Errata Sheet

December 23, 1998 / Release 1.1

Device:	SAB 80C166-M SAB 80C166-M-T3 SAB 80C166-M-T4 SAB 80C166-M25
Stepping Code / Marking:	ES-DA, DA
Package:	MQFP-100

Problem 11: Input Leakage Current (I_{oz1}) at Port 5

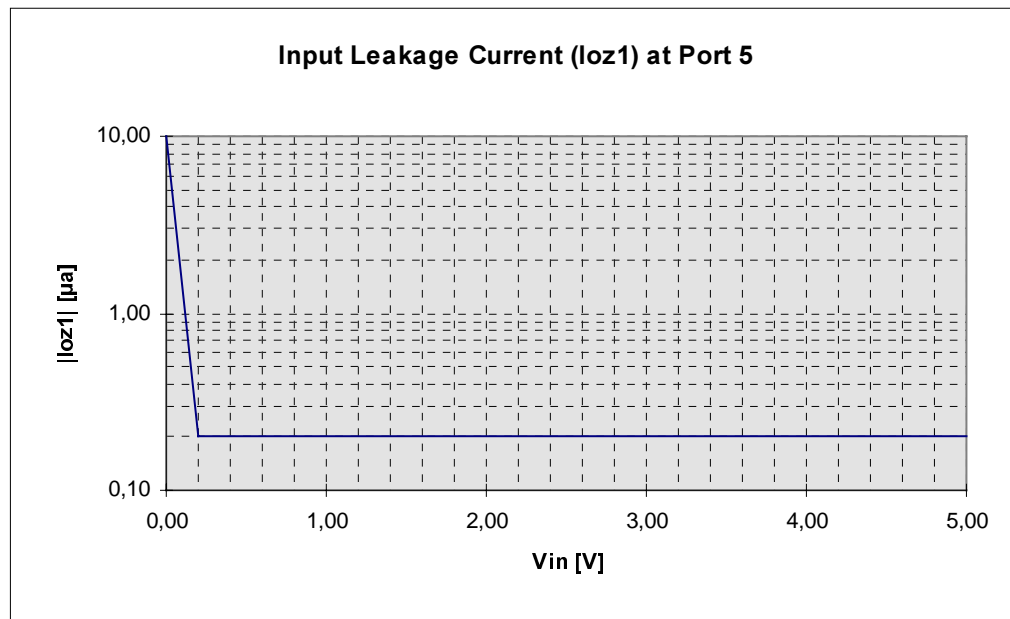
The input leakage current (I_{oz1}) of some devices can deviate from the actual specified limit value of ±200 nA at input voltages (V_{in}) close to 0 V. High ambient temperature and maximum supply voltage lead to a maximum increase of the leakage current.

The following equation describes the behavior of the leakage current for input voltages between 0 V and 200 mV and covers all specified operating conditions. This equation stands for an exponential decrease from ±10 µA leakage current at V_{in} = 0 V to ±200 nA at V_{in} = 200 mV.

Input Voltage (V _{in})	$0 \leq V_{in} \leq 200 \text{ mV}$	$200 \text{ mV} \leq V_{in} \leq V_{cc} \text{ } ^1)$
Input Leakage Current (I _{oz1})	$I_{oz1} = \pm a \cdot e^{(b \cdot V_{in})}$ a = 10 µA; b = -0,0196 mV ⁻¹	I _{oz1} = ±200 nA

¹⁾ **Note:** For input voltages above 200 mV the input leakage specification remains unchanged.
